SODA MOUNTAIN SOLAR PROJECT (24-OPT-03)

**CEC DATA RESPONSE
SET #1**

OCTOBER 2024

Figure 1-1. Project site location and existing conditions pre-construction.

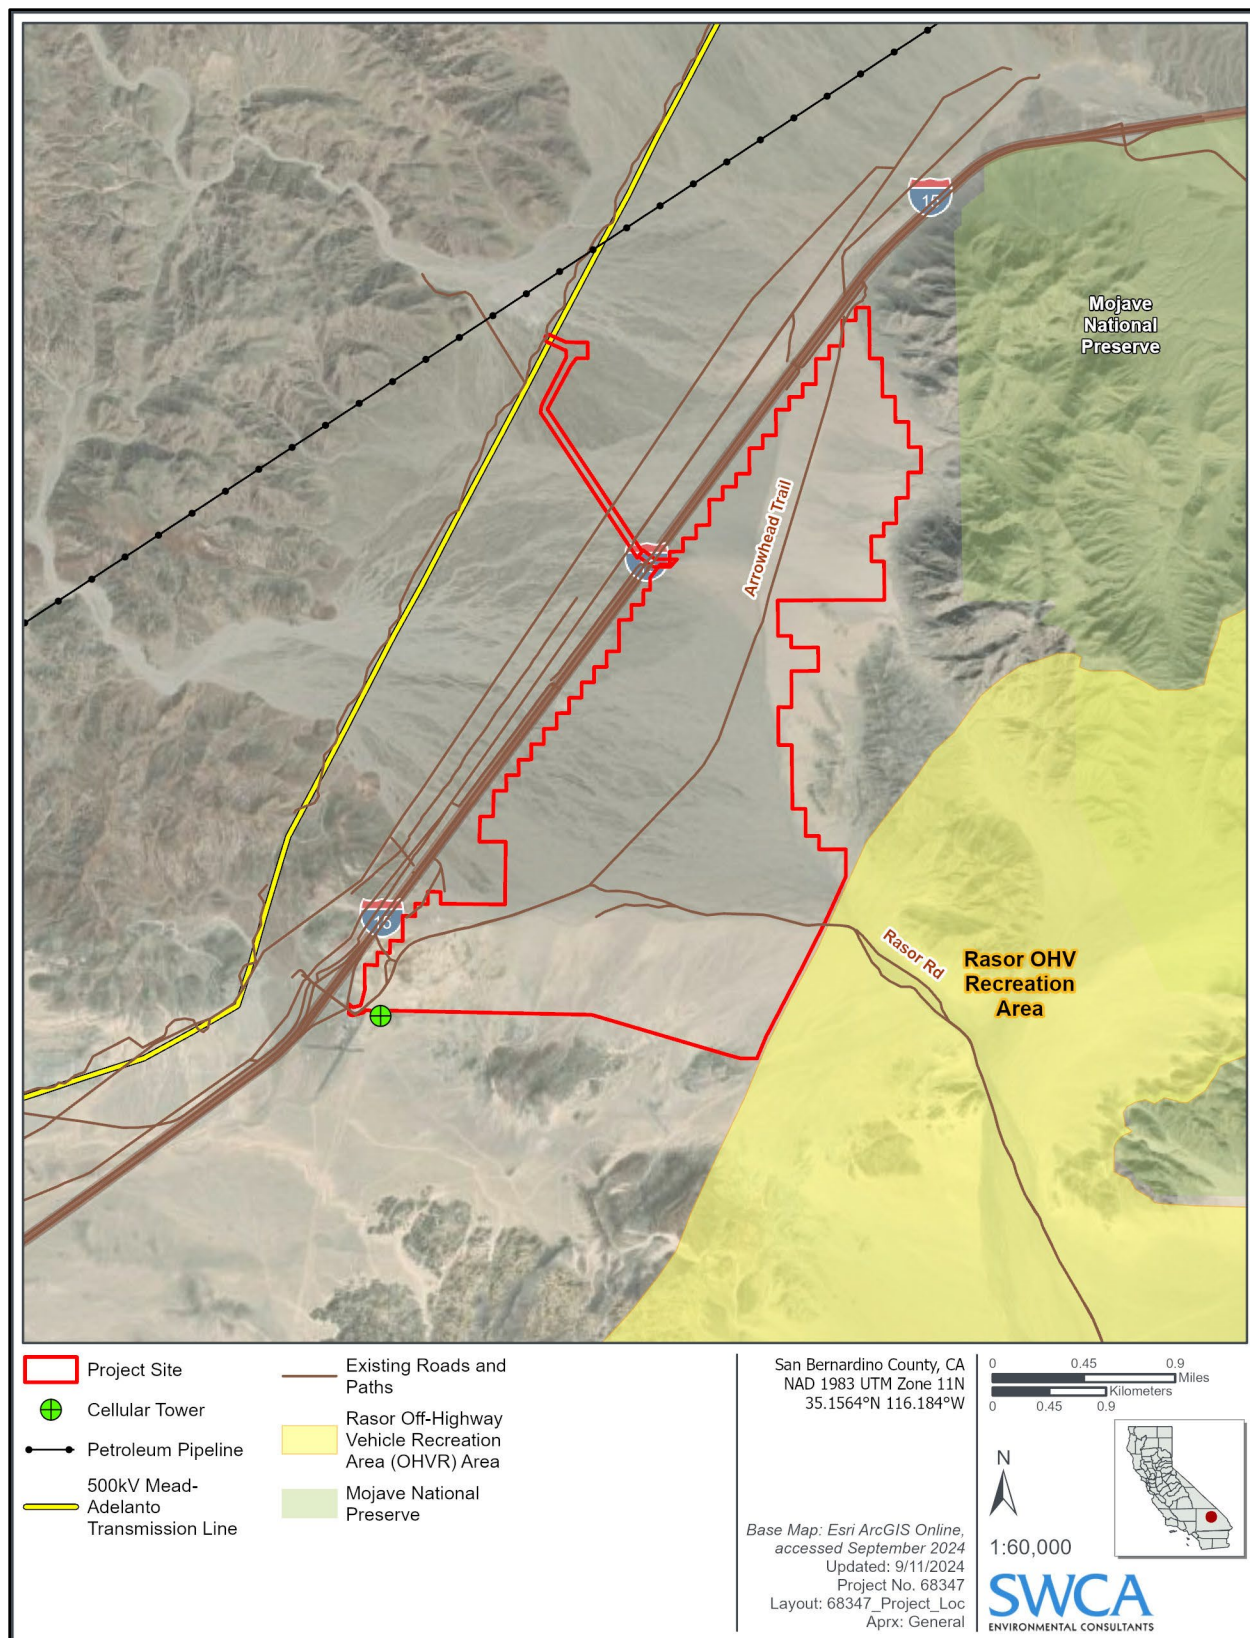
DR ES-1: Update Figure 2-2 to include the existing electrical distribution line, wireless cellular telephone towers, two fiber-optic cables, and two fuel pipelines.

DR ES-2: Please provide a full-page color photographic reproduction depicting the visual appearance of the project site prior to construction, and a full-page color simulation or artist's rendering of the site and all project components at the site, after construction. This should clearly show the project site, including all project components. It may be useful to show the photographic simulation from an angle and at a vantage point that will show the project components.

Response: Chapter 1 Executive Summary has been updated and docketed to respond to this data request. Specifically, Figure 1-1 has been updated to include the existing electrical distribution line, wireless cellular telephone towers, two fiber-optic cables, and two fuel pipelines. Please see Exhibit 4 of this data request response.

Response: Chapter 1 Executive Summary has been updated and docketed to respond to this data request. Specifically, Figure 1-1 provides a full-page color photographic reproduction depicting the visual appearance of the project site prior to construction. Figure 1-2 provides full-page color photographic reproduction depicting the visual appearance of the project site and all project components at the site, after construction. Please see Exhibit 4 of this data request response. Photographic simulations from various angles and vantage points are provided in Appendix B, Visual Resources Report. The Visual Resources Report will be updated and docketed to address the CEC data requests in Data Request Response #2.

Figure 3.9-2. Schools and sensitive receptors (1:24,000 scale, north).

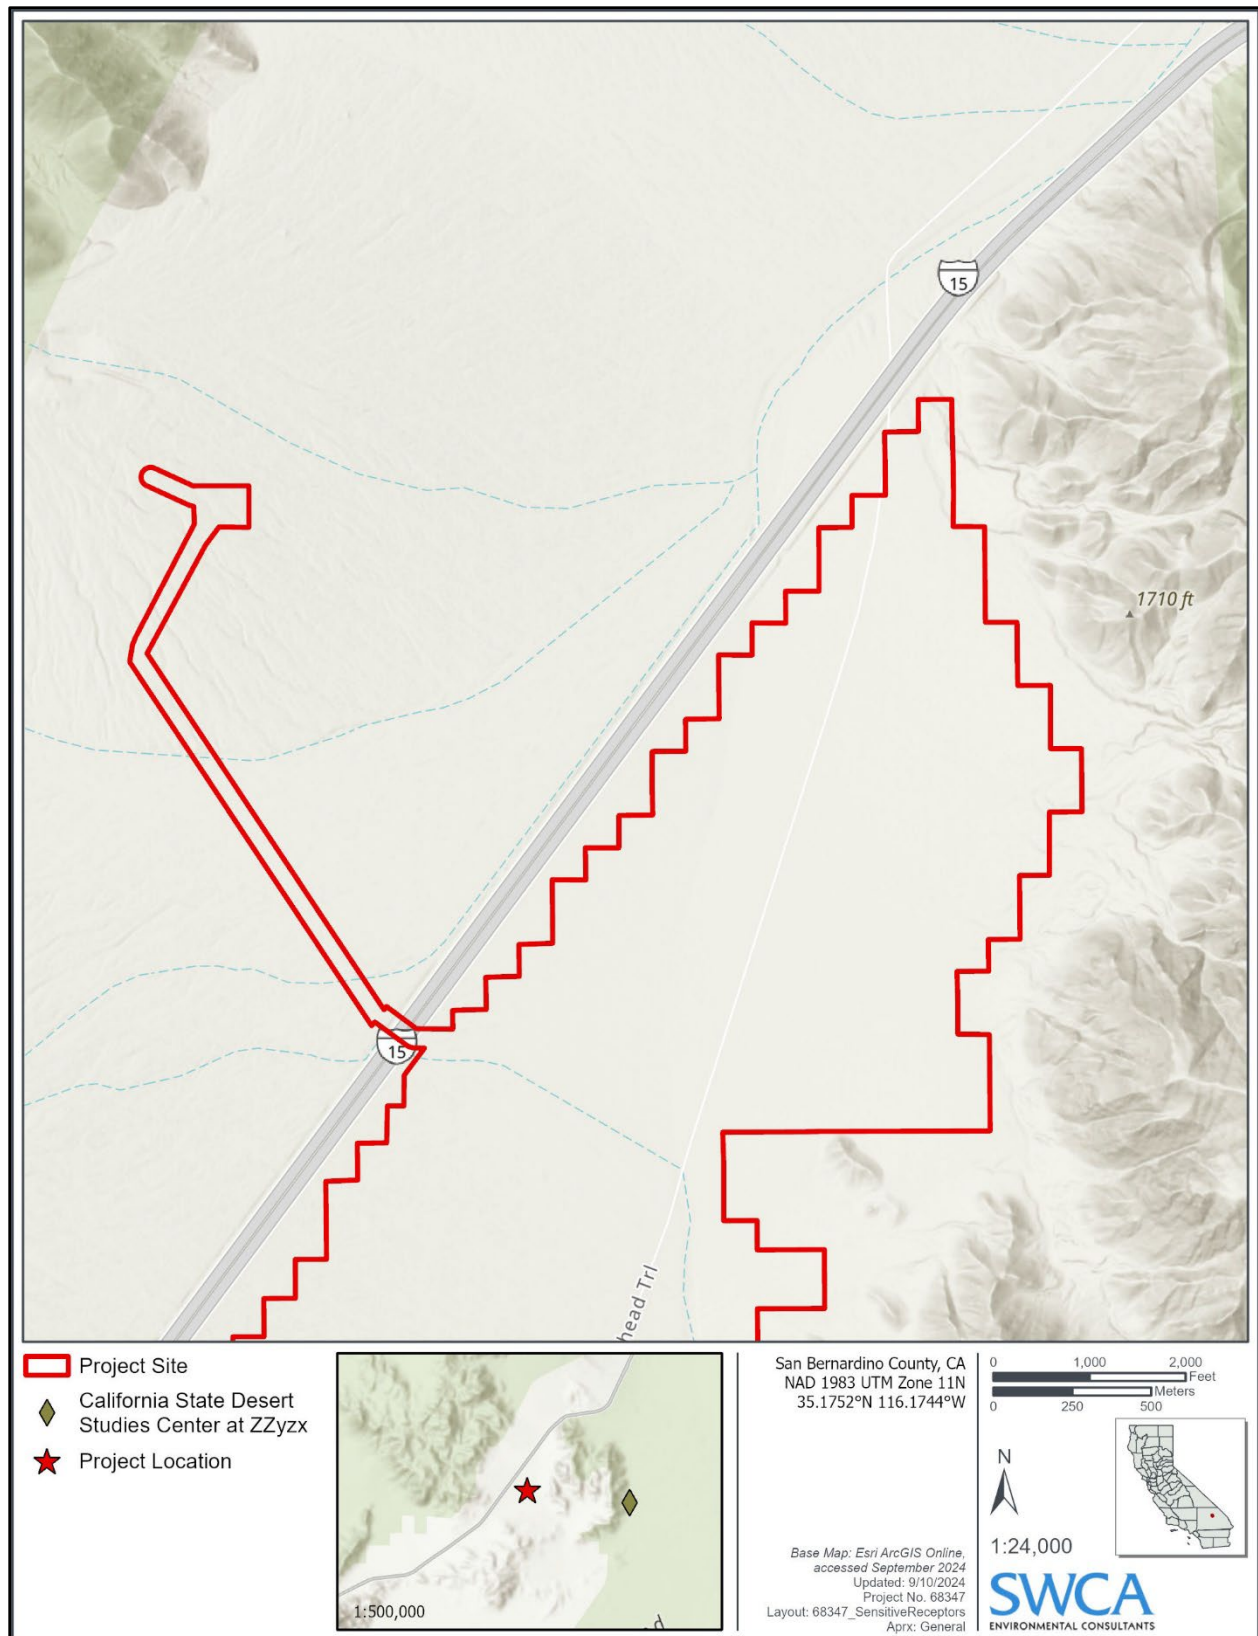
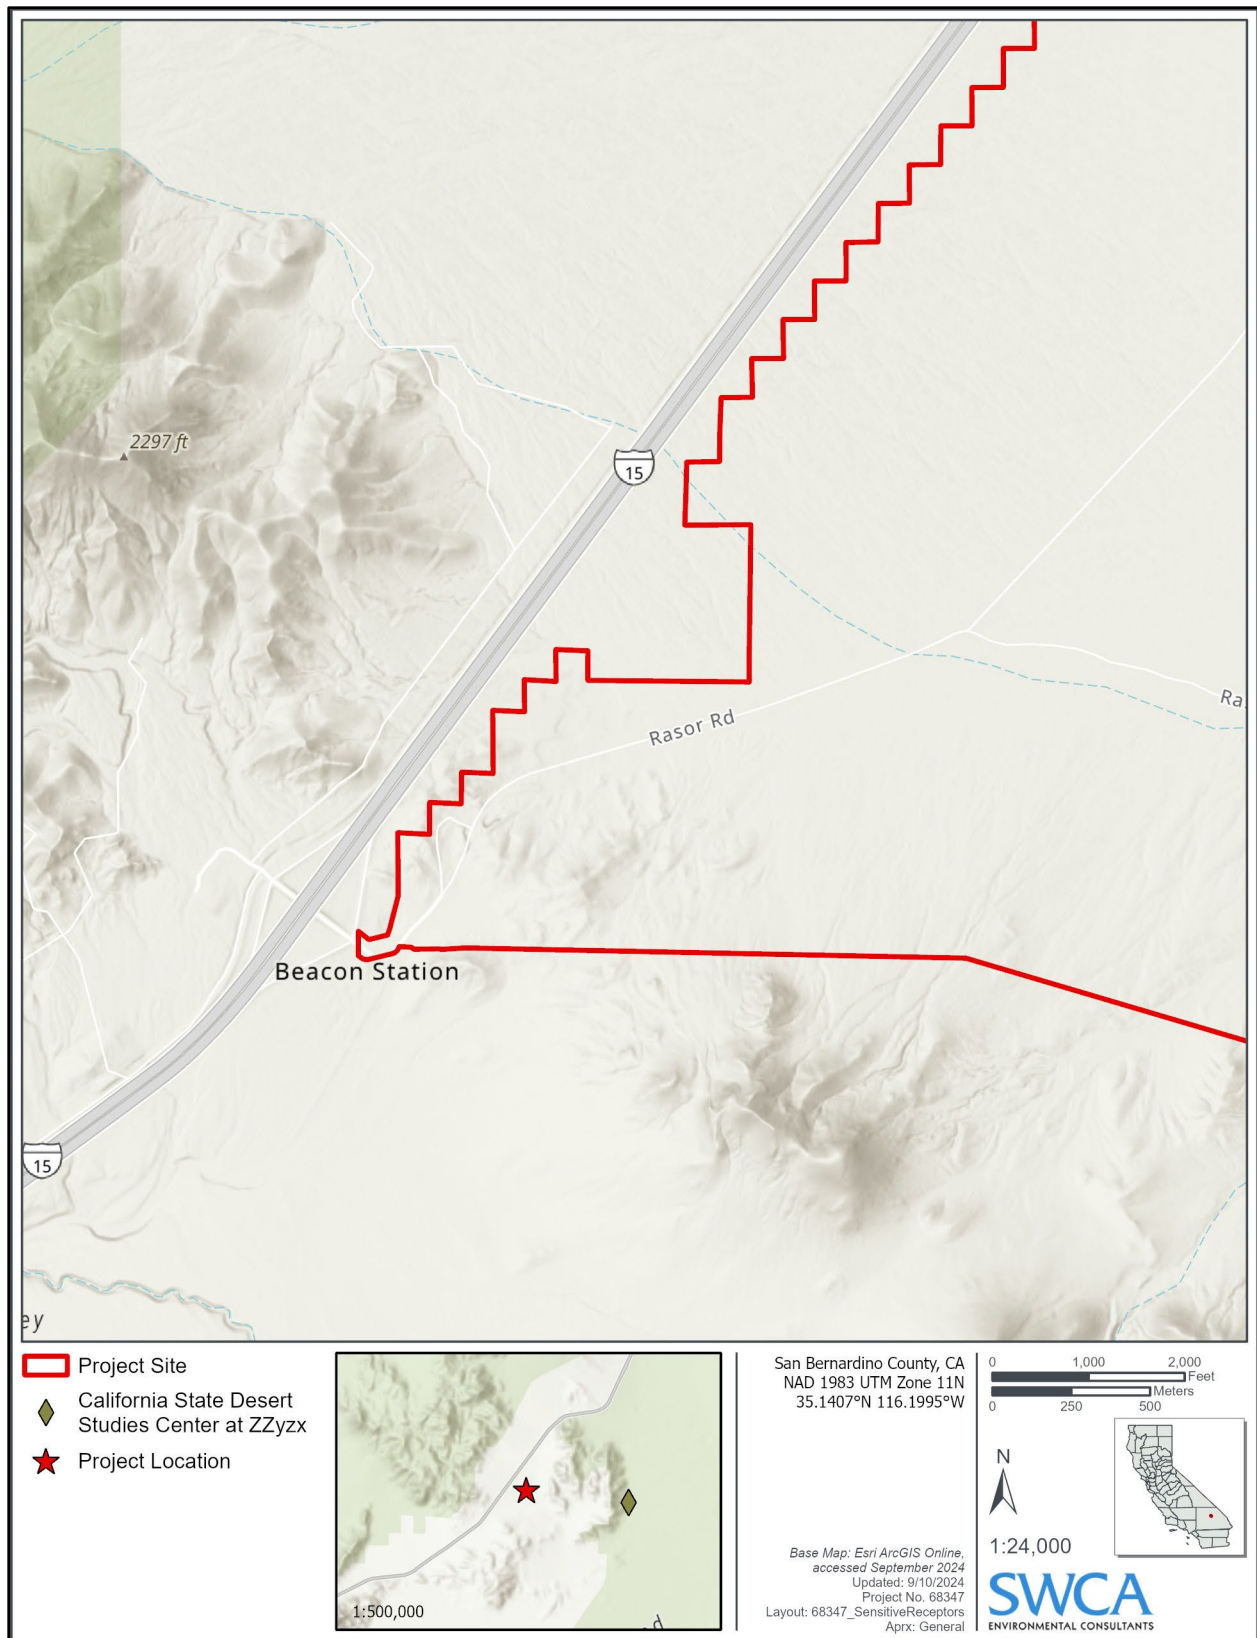
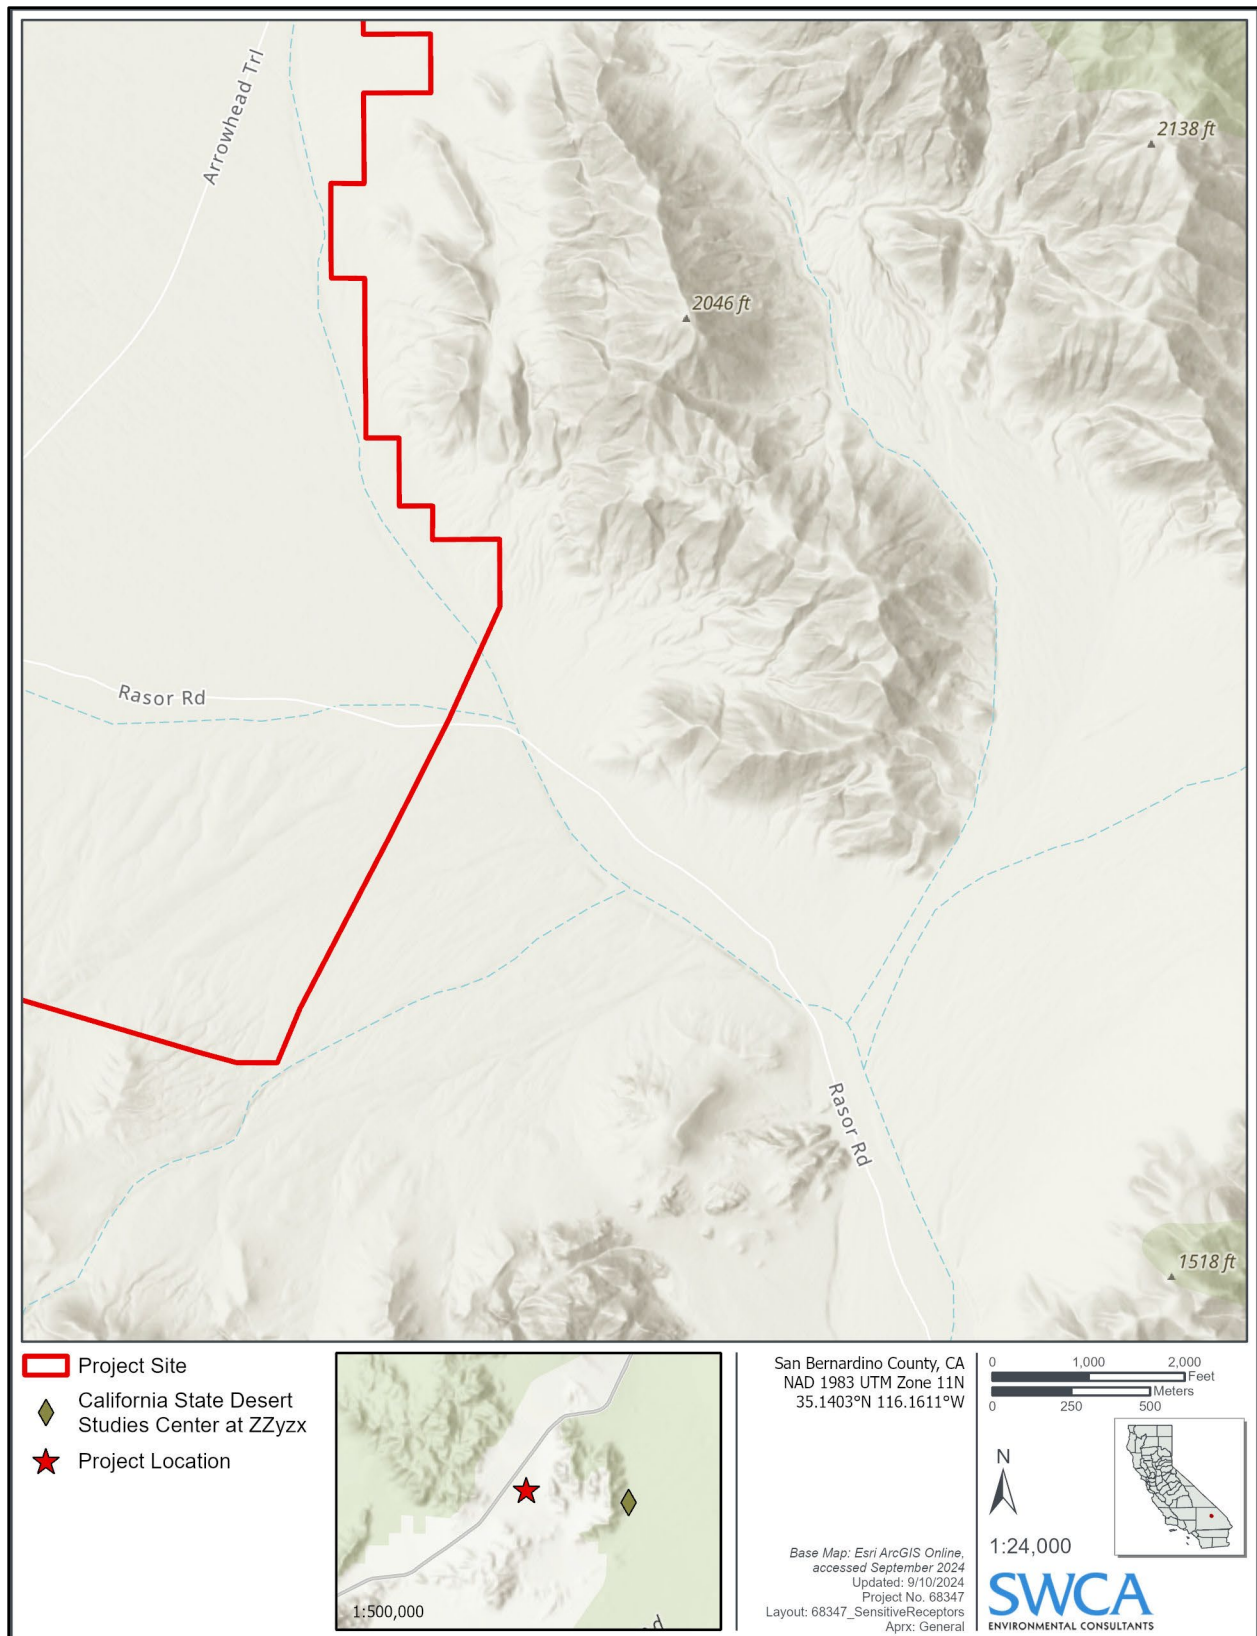
DR HAZ-2: Please provide a figure with a scale at 1:24,000.

Response: Section 3-9 Hazards and Hazardous Materials has been updated and docketed to respond to this data request. Specifically, Figures 9.2, 9.3 and 9.4 on Pages 3.9-20 -3.9-22 have been updated. Please see Exhibit 6 of this data request response.

Figure 3.11-1. Project location and management agency.

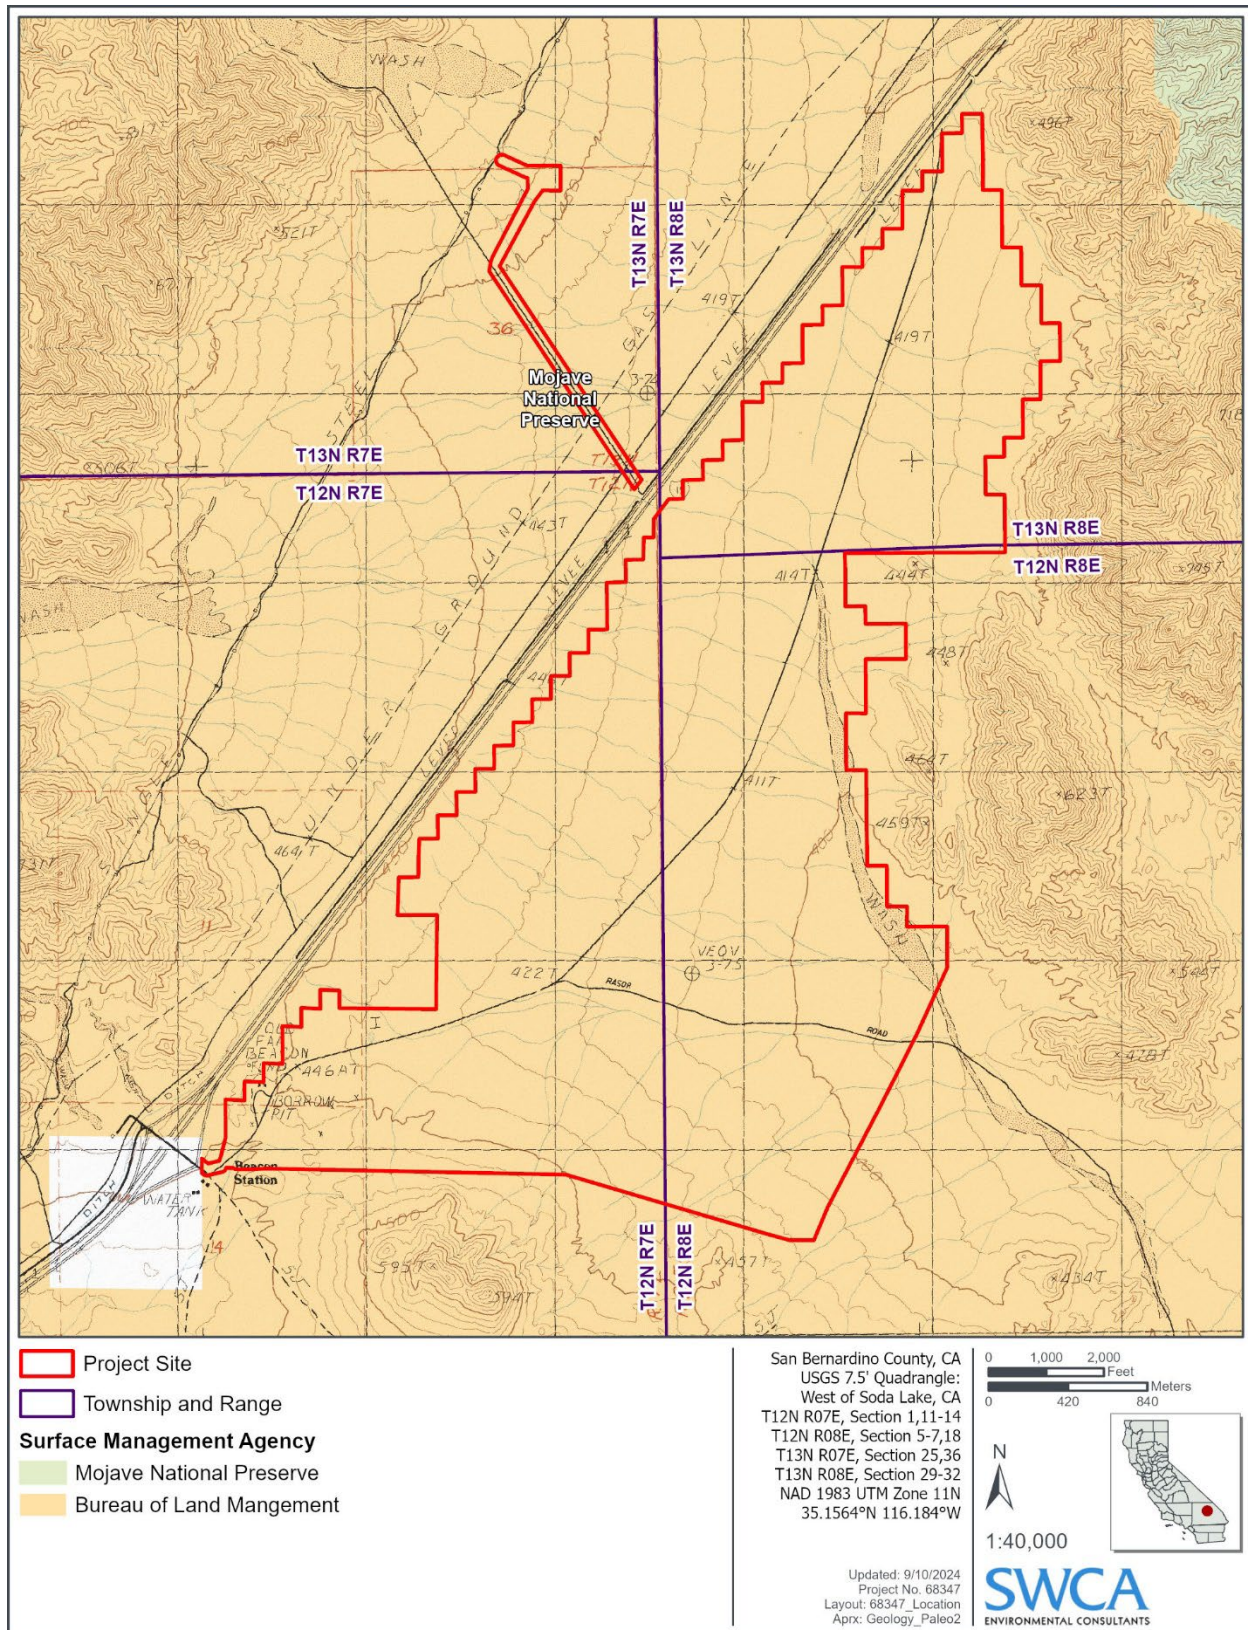
DR LAND-2: Please correct Figure 2-3 to reflect the land management data that is most up-to-date and to show that the project site would be located entirely on BLM managed land. Provide the associated updated Geographic Information System (GIS) shape files.

Response: Section 3-11 Land Use has been updated and docketed to respond to this data request. Specifically, Figure 3.11-1 has been updated to reflect the land management data that is most up-to-date and to show that the project site would be located entirely on BLM managed land. Please see Exhibit 7 of this data request response. Figure 2-3 will be updated and docketed with Batch 2 responses. The CEC has been provided with the associated updated Geographic Information System (GIS) shape files concurrent with this submittal.
